STAFF RECOMMENDATION

1501 Holly Street

October 21, 2015

Application: Demolition: outbuilding; New construction—Detached Accessory Dwelling Unit

Figure 4. The outbuilding does not appear on the 1957 Sanborn Map.

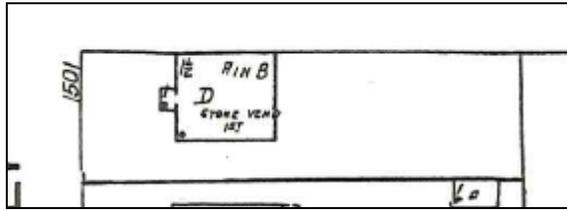
Demolition. The existing outbuilding will be demolished. The date of construction for the outbuilding is unknown, but it does not appear on the 1957 Sanborn Map (Figure 4). The outbuilding does not contribute to the historic character of the site or the neighborhood. Staff therefore finds that the proposed demolition meets section IV.B.2 of

the design guidelines for appropriate demolition and does not meet Section IV.B.1. for inappropriate demolition.

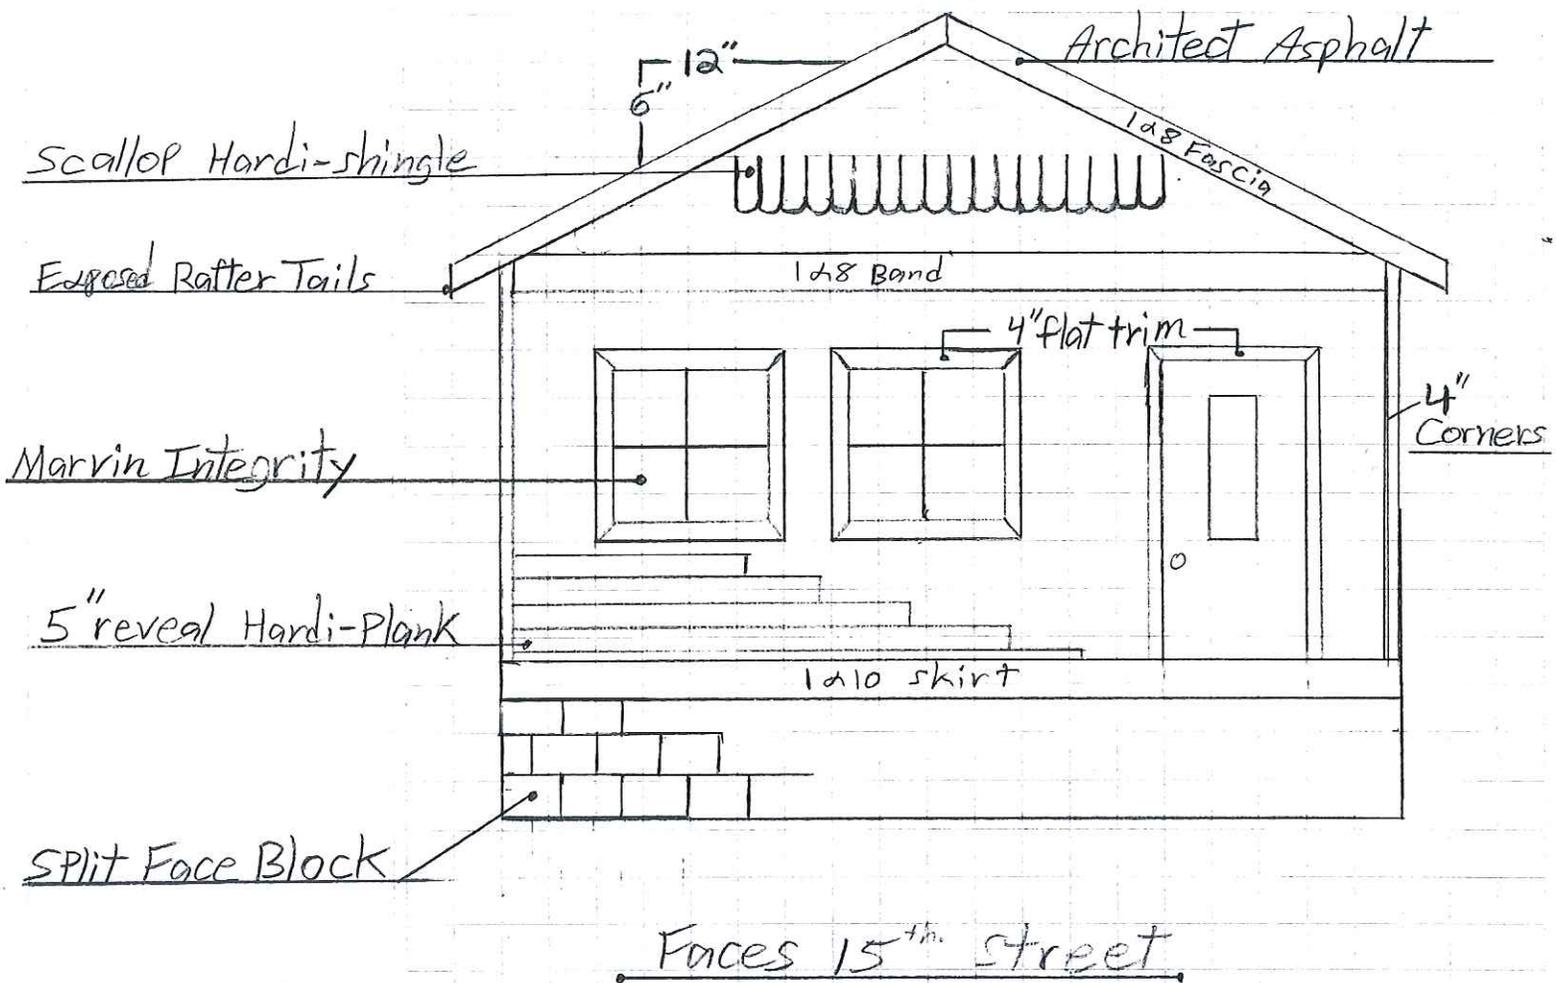
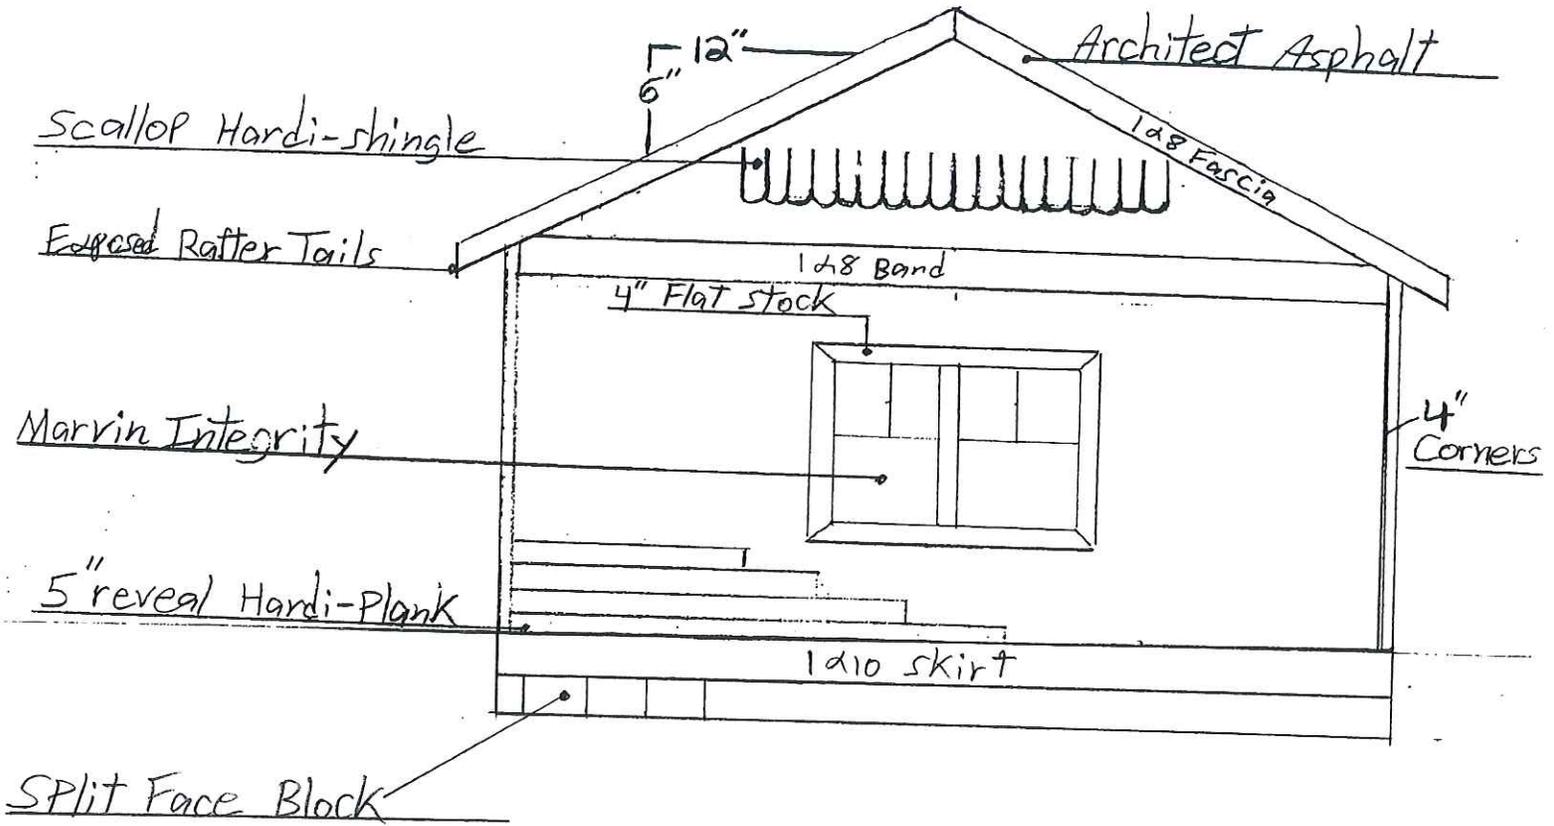
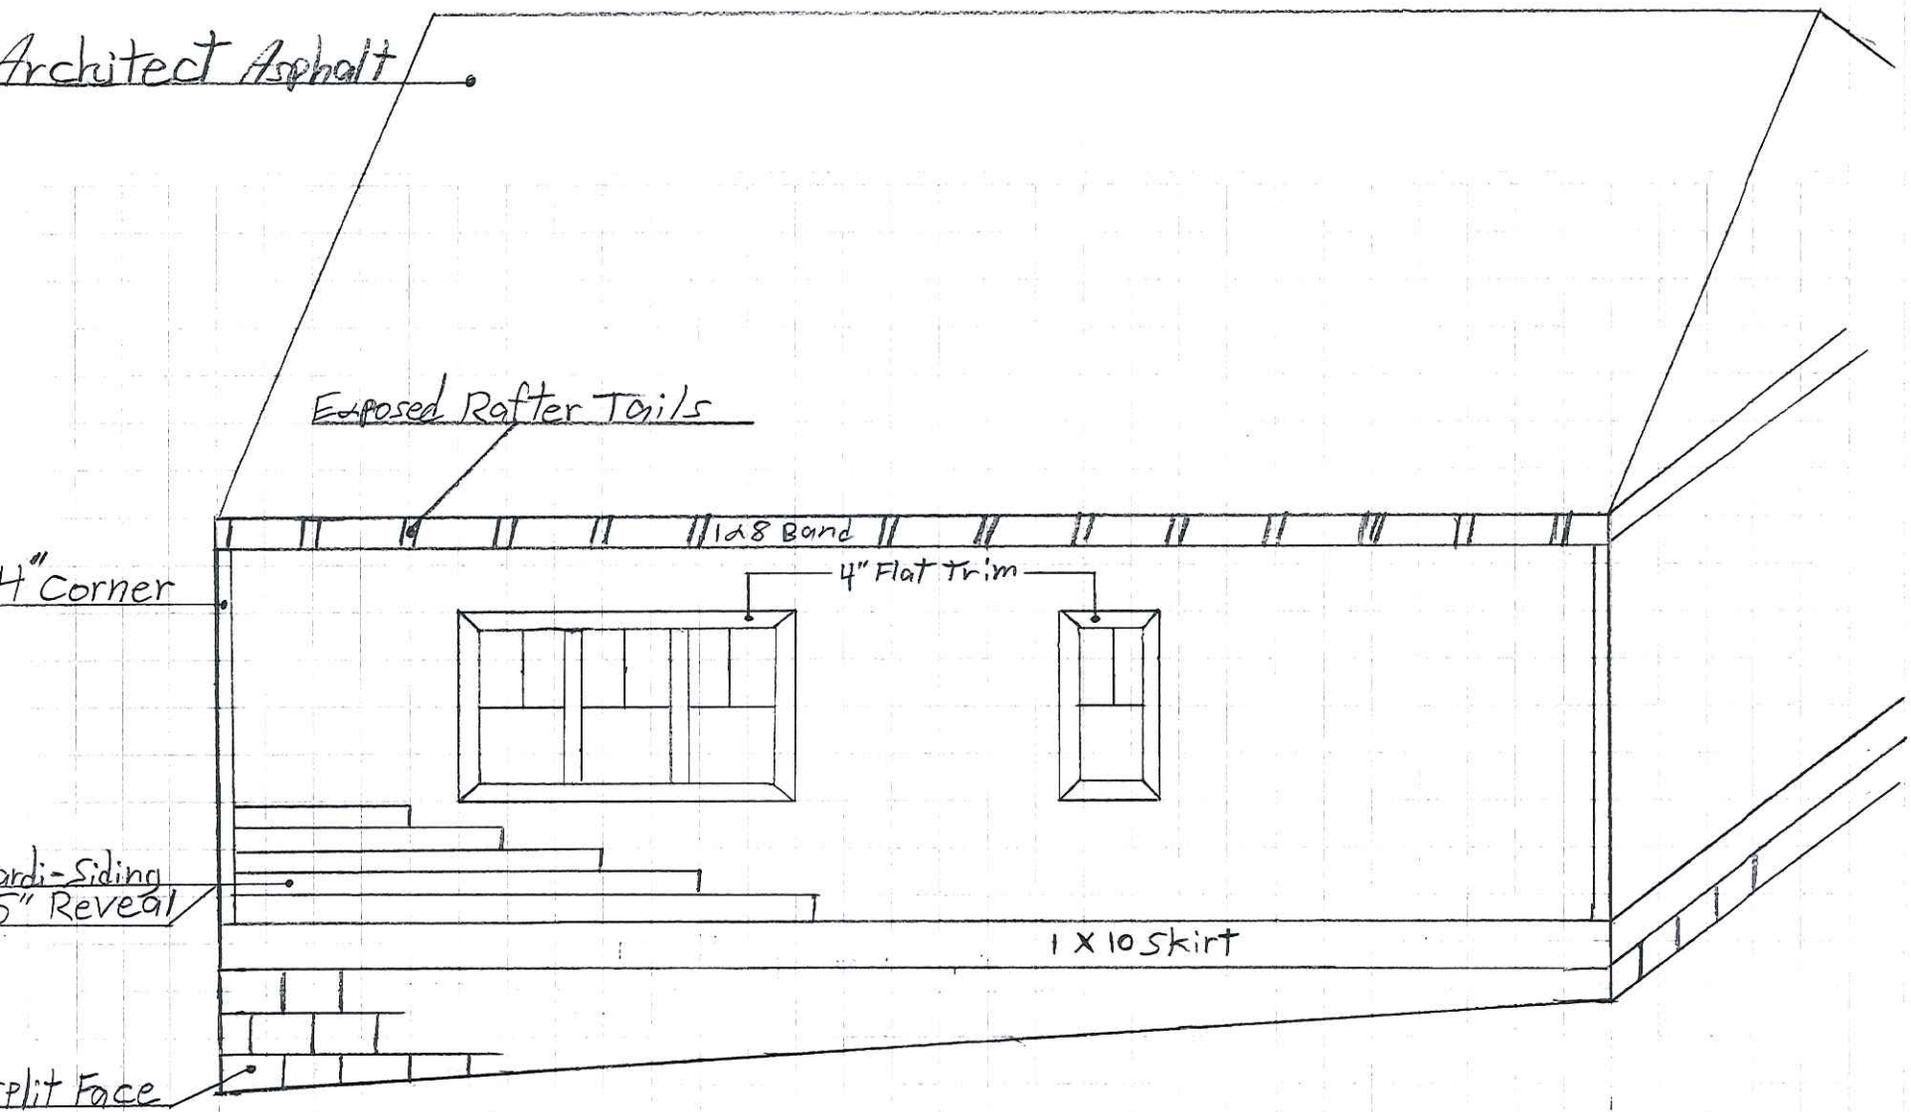
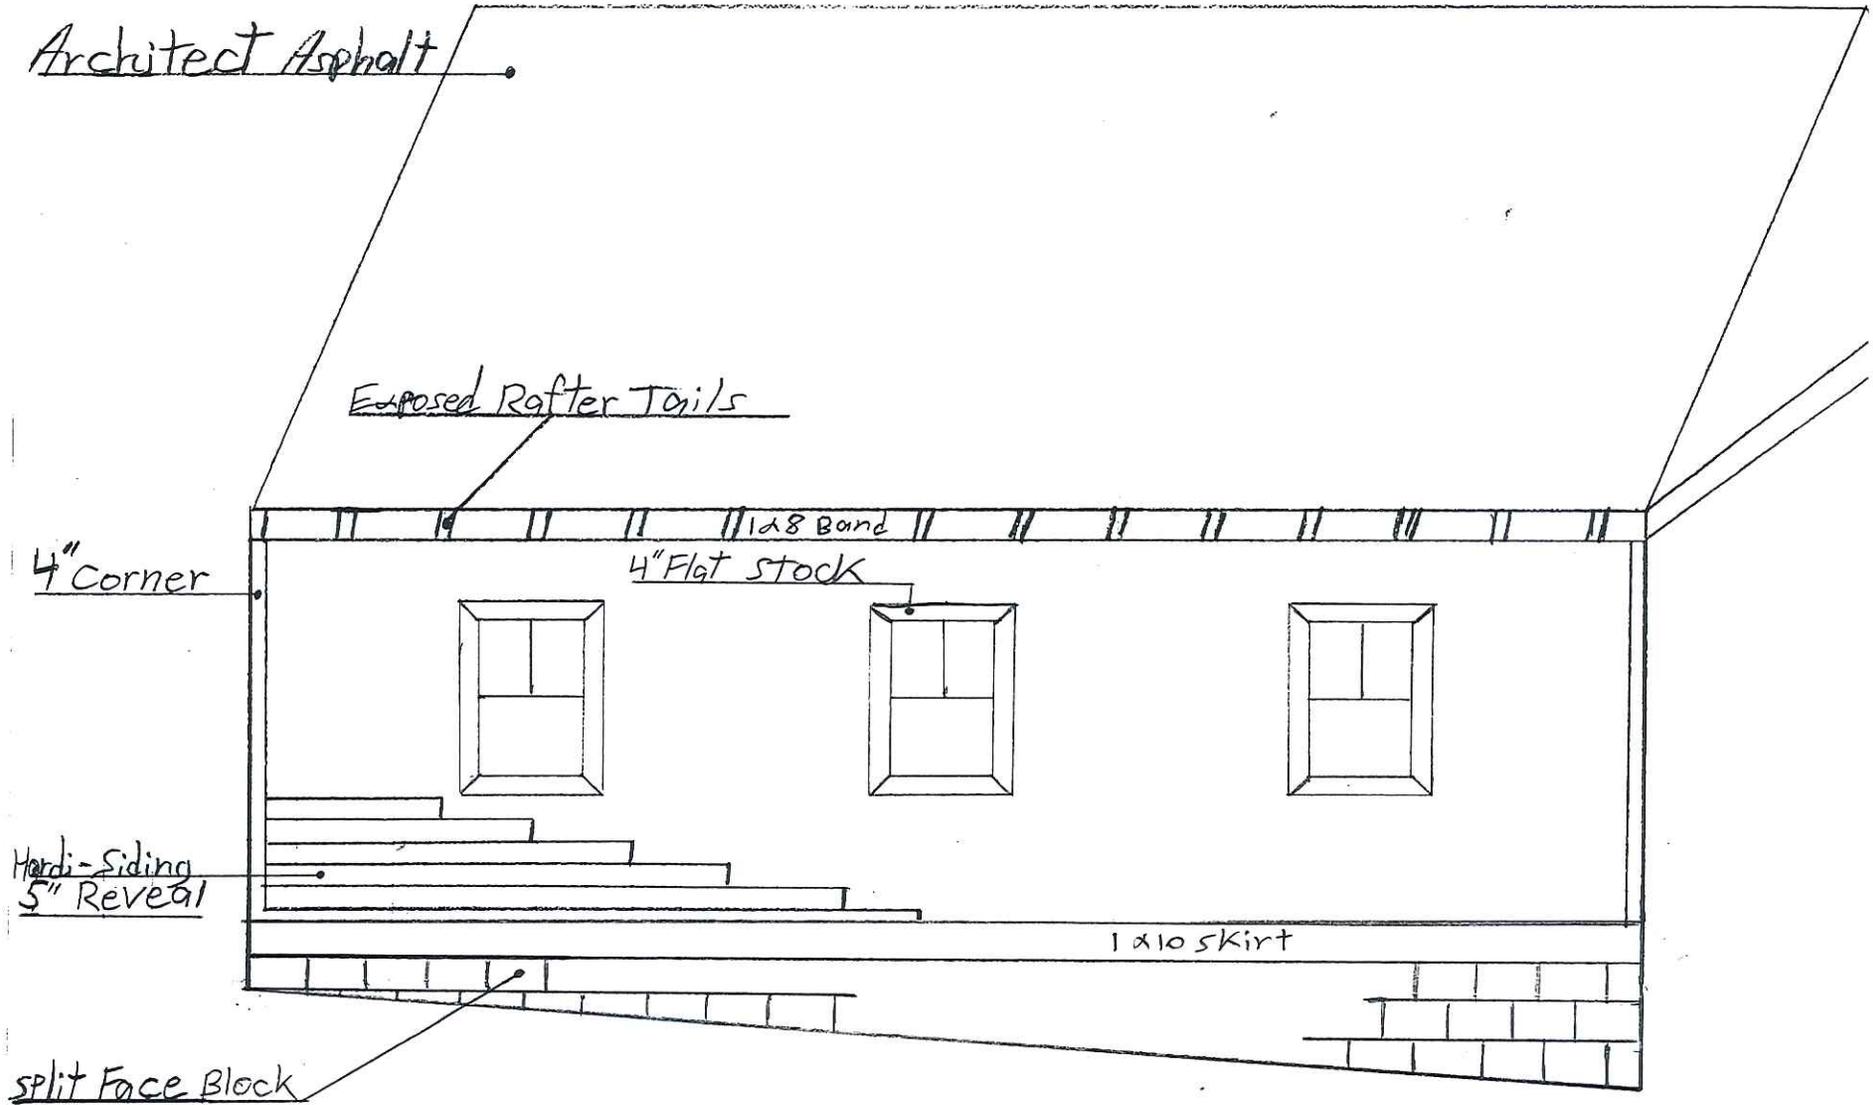
The proposed DADU will be one-story and with a footprint of six hundred square feet (600 sq. ft.). It will not contain a garage. It will be subordinate to the historic structure. It will be approximately seventeen feet (17') tall, which is lower than the height of the historic house. Its eave height will ten feet (10').

The materials for the DADU have all been approved by the Commission in the past, and include cement fiberboard siding with a five inch (5”) reveal, cement fiberboard trim, wood brackets, asphalt shingles, Marvin Integrity windows, and a split face block foundation. Staff asks to approve the shingle color and the windows and doors prior to purchase and installation.

The site has a significant cross slope of at least four to six feet (4'-6') (Figure 5). Because of the cross slope, the 15th Street façade will have a taller foundation of approximately three blocks, and the foundation height will decrease towards the interior of the lot. Because of the taller foundation, the entry facing 15th Street will likely need a stair landing. Staff recommends approval of the materials and design of the stairs and landing.

1. Staff approve the design and material of the entry stair and landing;
2. Staff approve the final details, dimensions and materials of windows and doors prior to purchase and installation;
3. Staff approve the roof shingle color; and
4. Staff receive a copy of the filed restrictive covenant for the detached accessory dwelling unit, prior to issuing permit.
